Final Set, Jefferson Village Phase II  
(Bulletin 6)

JEFFERSON VILLAGE

TYPICAL PAVEMENT CROSS SECTIONS

HOR. SCALE: NO SCALE  
VER. SCALE: NO SCALE  
DATE: 3-27-00  
JOB NO.: DE99011  
FILE NO.: DE9911X1  
SHEET NO.: P-0.2

Neighborhood Development Corporation  
Spalding DeDecker Associates, Inc.  
607 Shelby, Suite 400, Detroit, MI 48226  
P (313) 967-4700 F (313) 967-4707

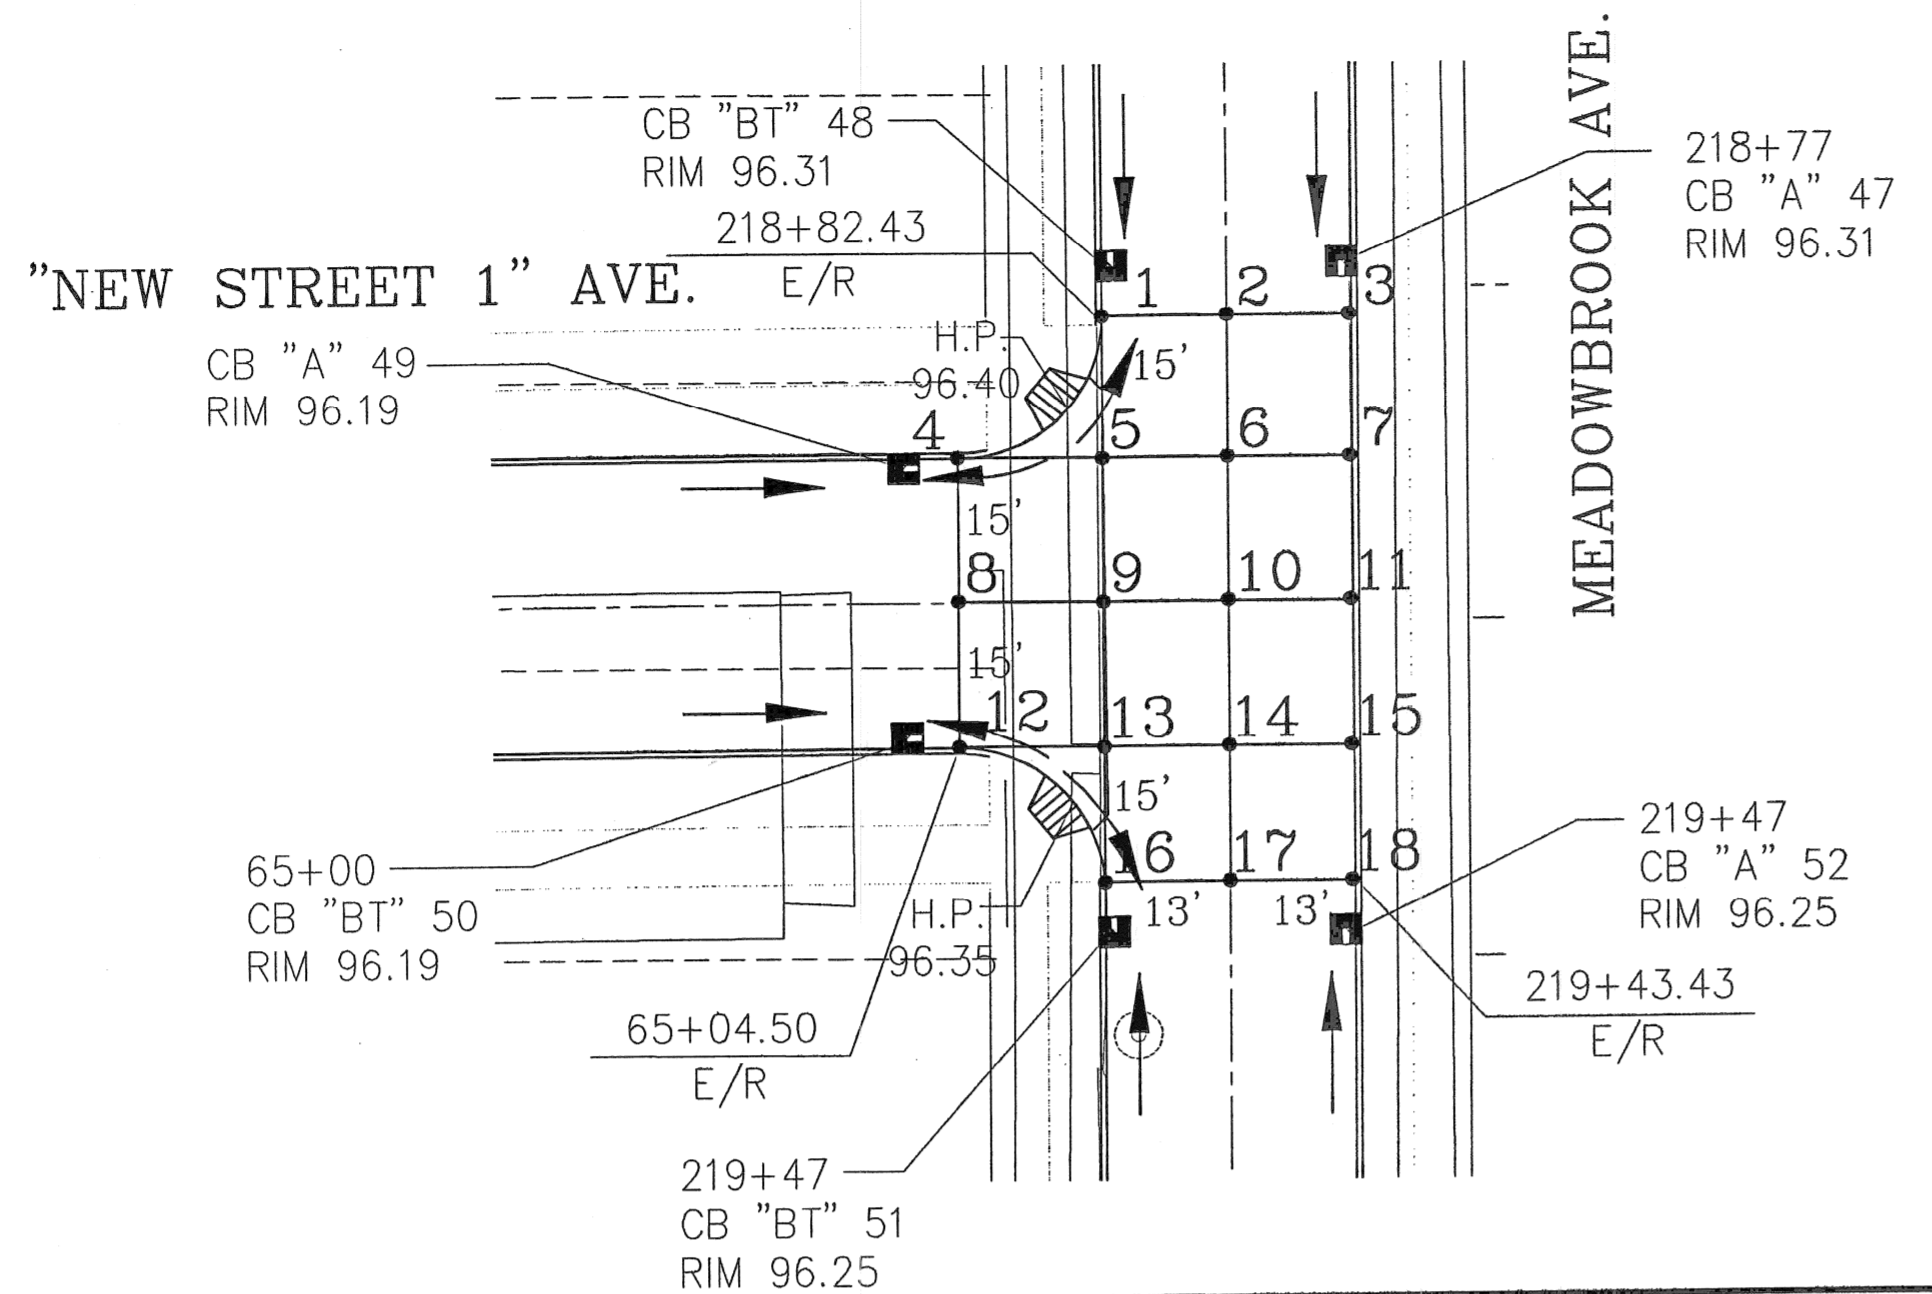
**NOTE:**  
WHERE PROPOSED ROLL CURB TIES INTO EXISTING CURB/7" HIGH CURB THE CONTRACTOR SHALL TAPER DIMENSIONS OF THE PROPOSED CURB OVER A LENGTH OF FIVE (5') FEET TO MATCH THE EXISTING/7" HIGH TOP OF CURB, FACE OF CURB AND BACK OF CURB. PAYMENT FOR THIS WORK SHALL BE CONSIDERED AS BEING INCLUDED IN THE COST FOR ALL OTHER CONCRETE PAVEMENT WORK.

JEFFERSON VILLAGE  
 FREUD AVE.  
 INTERSECTION DETAILS

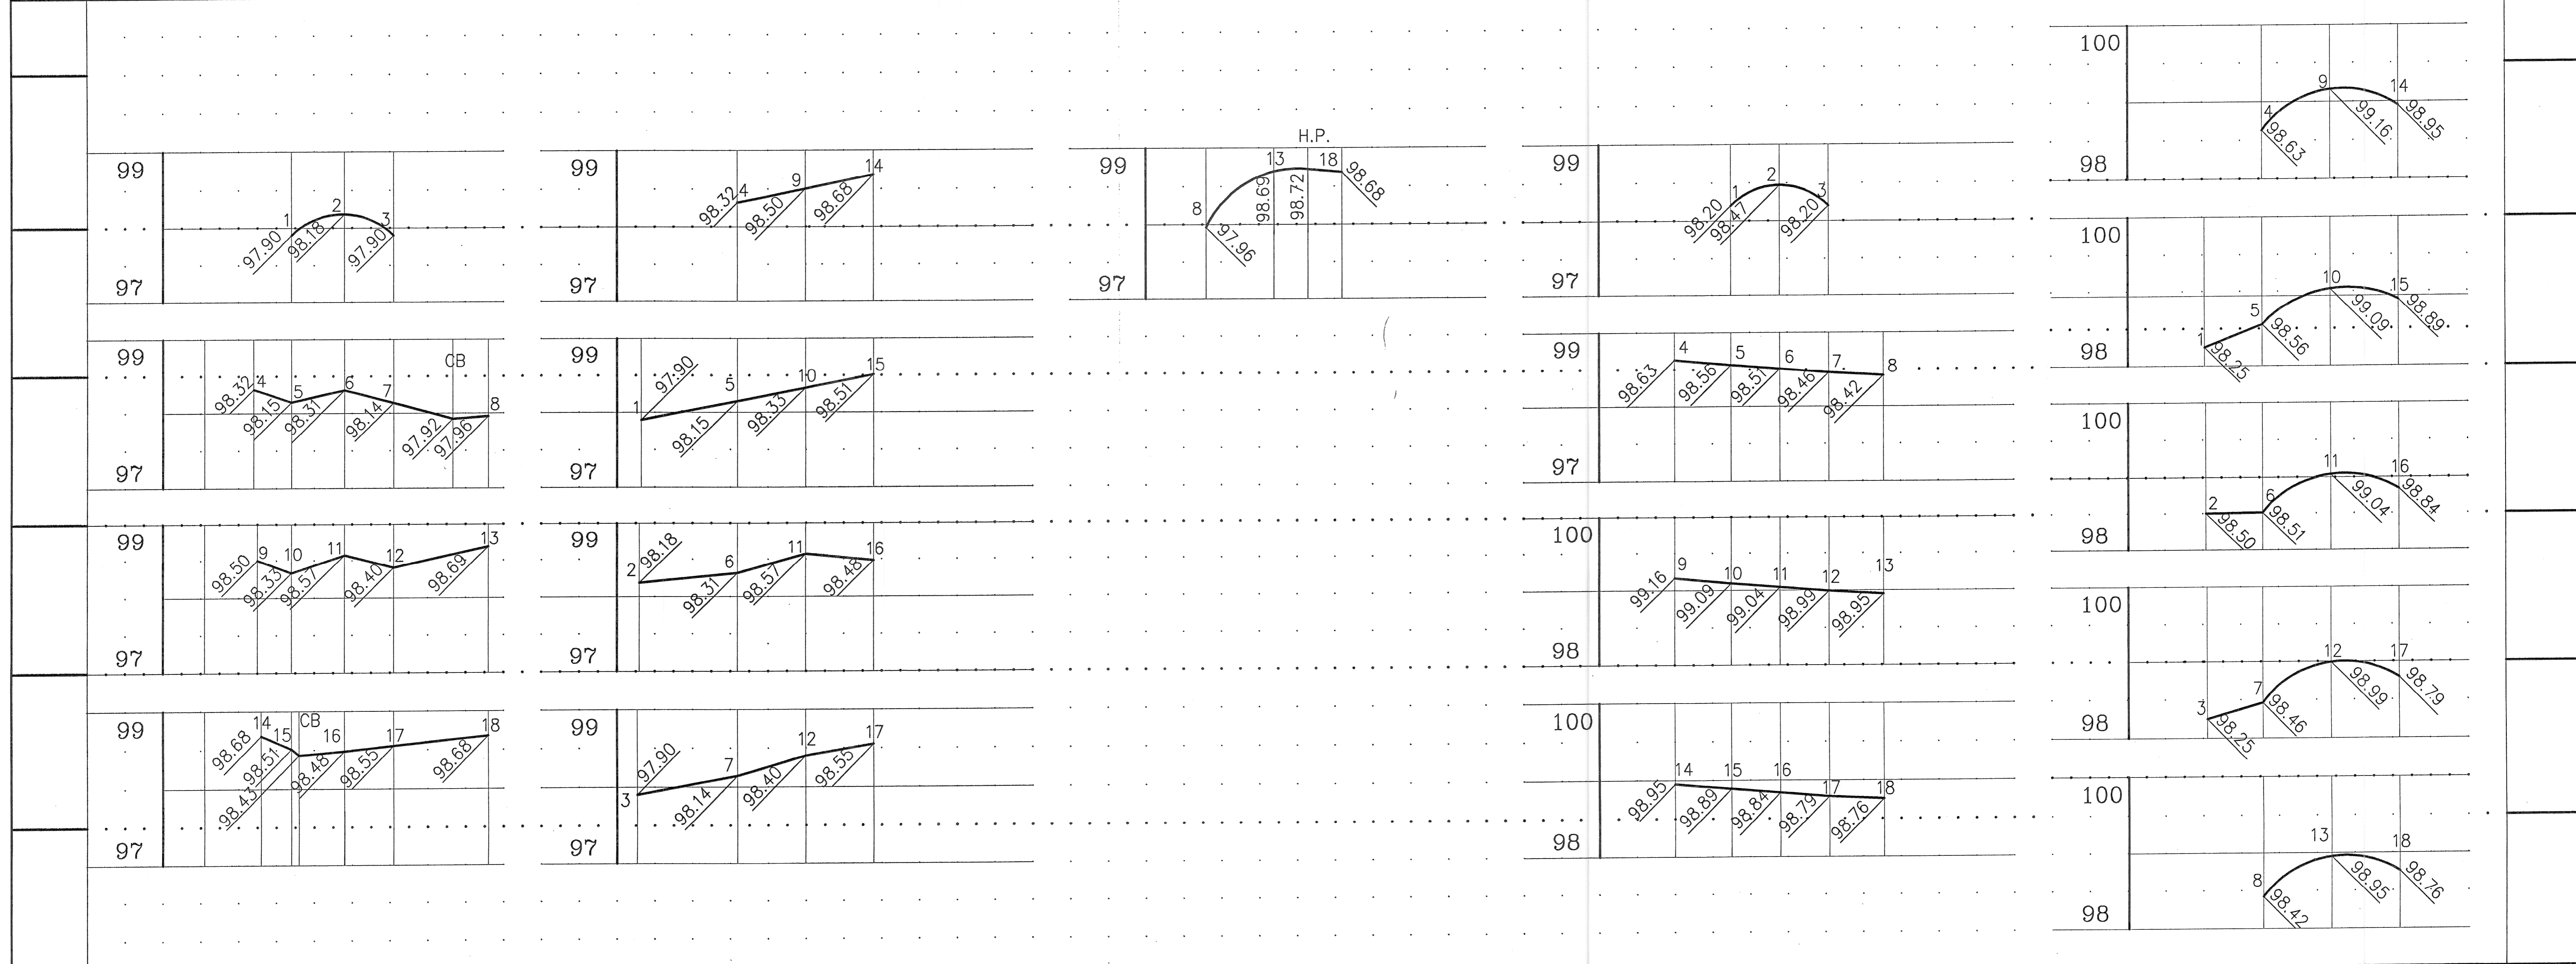
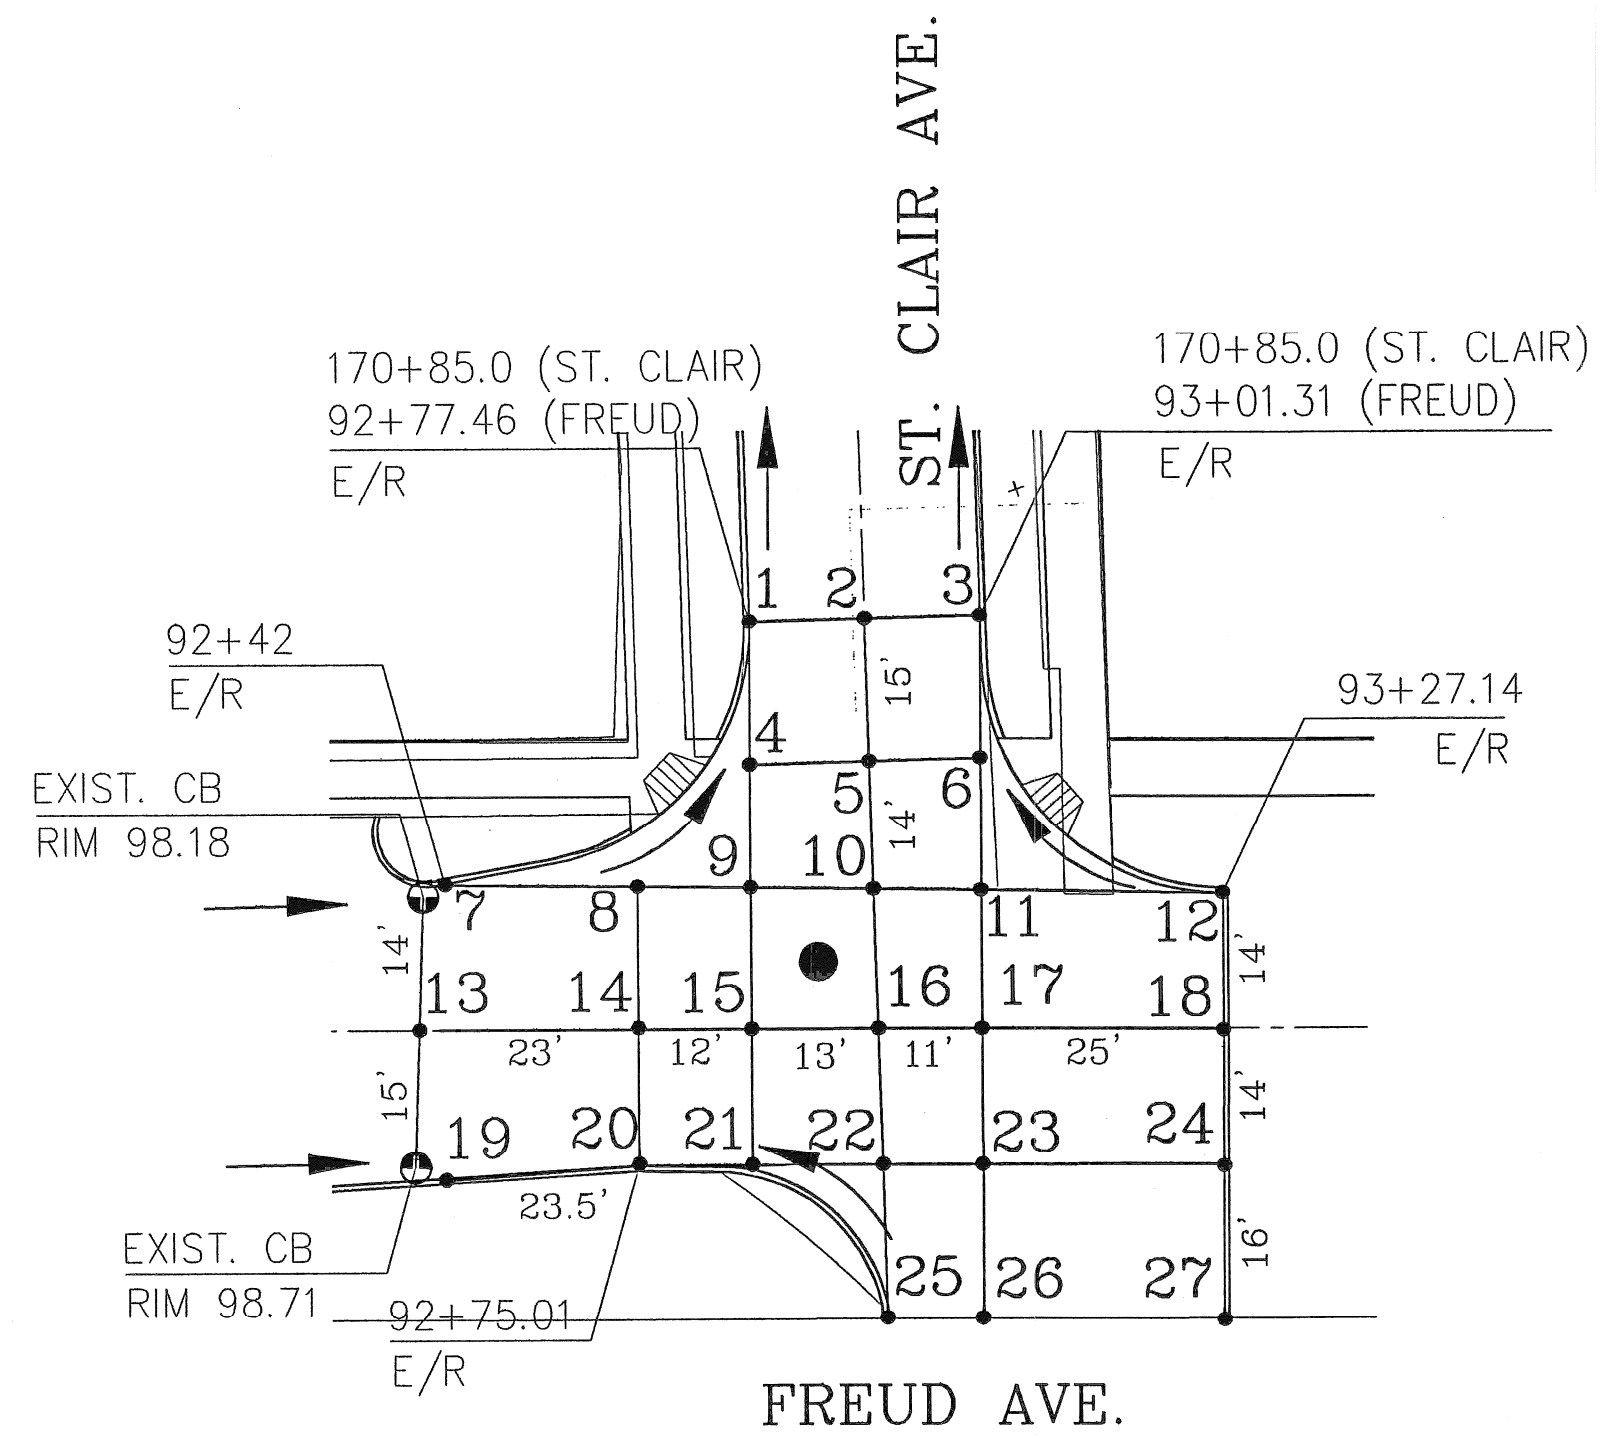
**NOTE:**  
 WHERE PROPOSED ROLL CURB TIES INTO EXISTING CURB/7" HIGH CURB THE CONTRACTOR SHALL TAPER DIMENSIONS OF THE PROPOSED CURB OVER A LENGTH OF FIVE (5) FEET TO MATCH THE EXISTING 7" HIGH TOP OF CURB, FACE OF CURB AND BACK OF CURB. PAYMENT FOR THIS WORK SHALL BE CONSIDERED AS BEING INCLUDED IN THE COST FOR ALL OTHER CONCRETE PAVEMENT WORK.

FREUD AVE.  
 INTERSECTION DETAILS

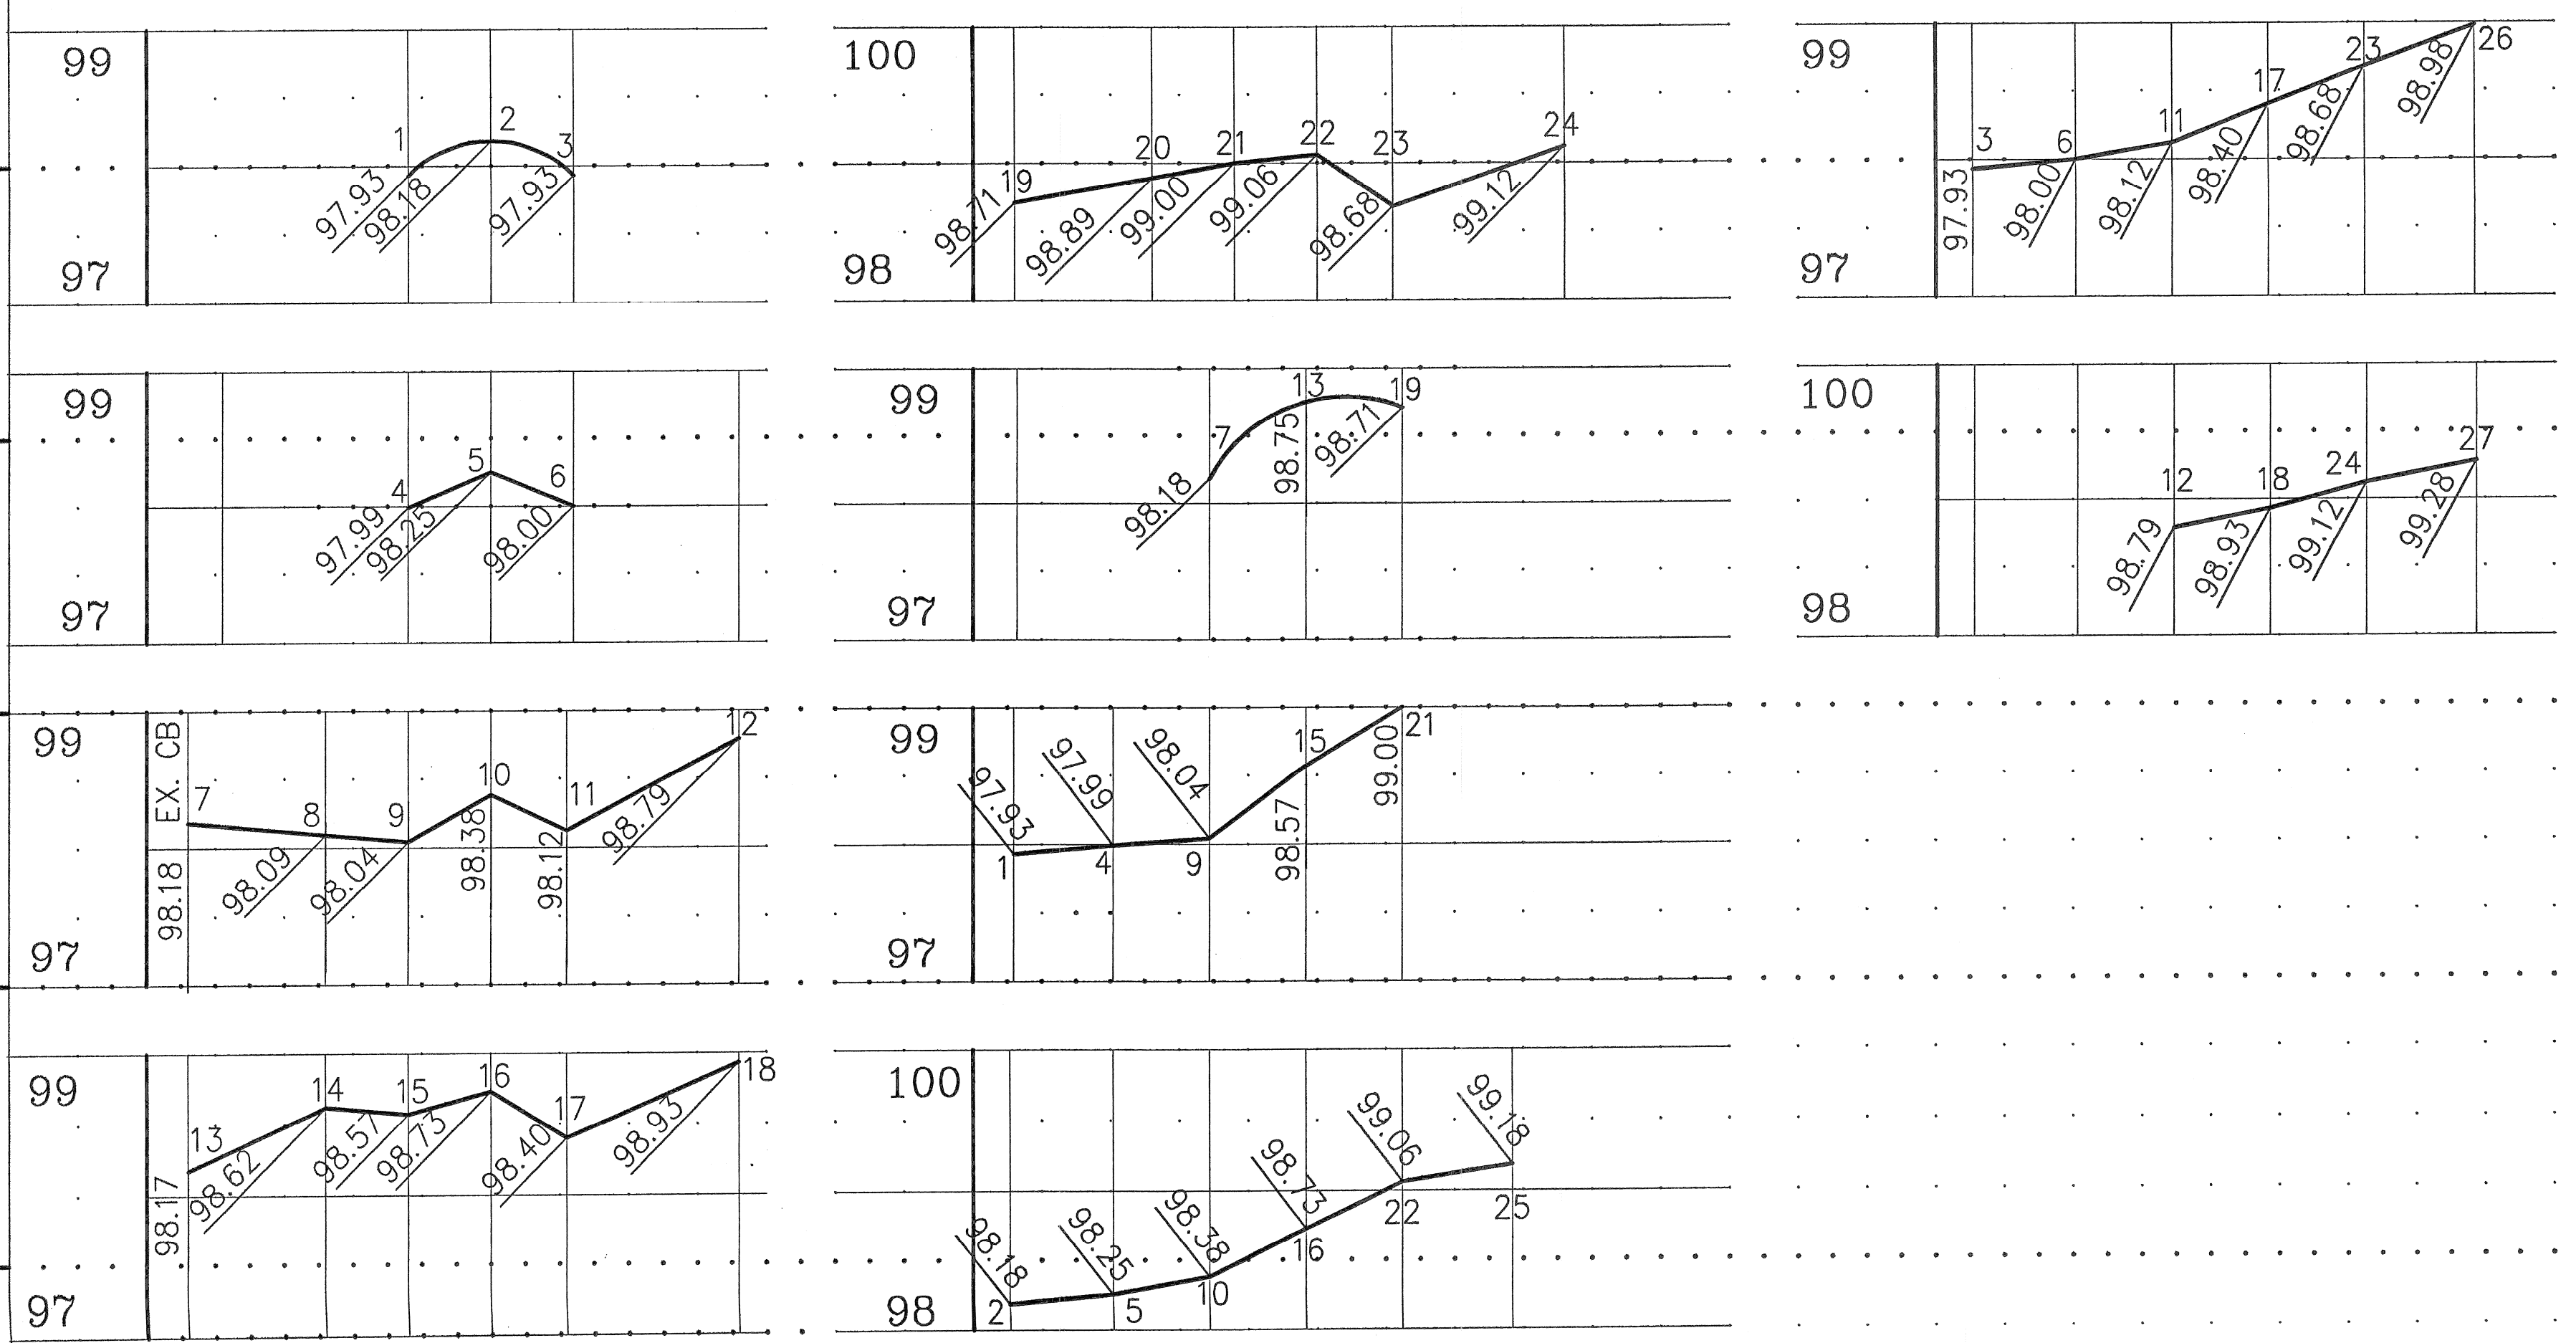
**NOTE:**  
 WHERE PROPOSED ROLL CURB TIES INTO EXISTING CURB/7" HIGH CURB THE CONTRACTOR SHALL TAPER DIMENSIONS OF THE PROPOSED CURB OVER A LENGTH OF FIVE (5) FEET TO MATCH THE EXISTING/7" HIGH TOP OF CURB, FACE OF CURB AND BACK OF CURB. PAYMENT FOR THIS WORK SHALL BE CONSIDERED AS BEING INCLUDED IN THE COST FOR ALL OTHER CONCRETE PAVEMENT WORK.
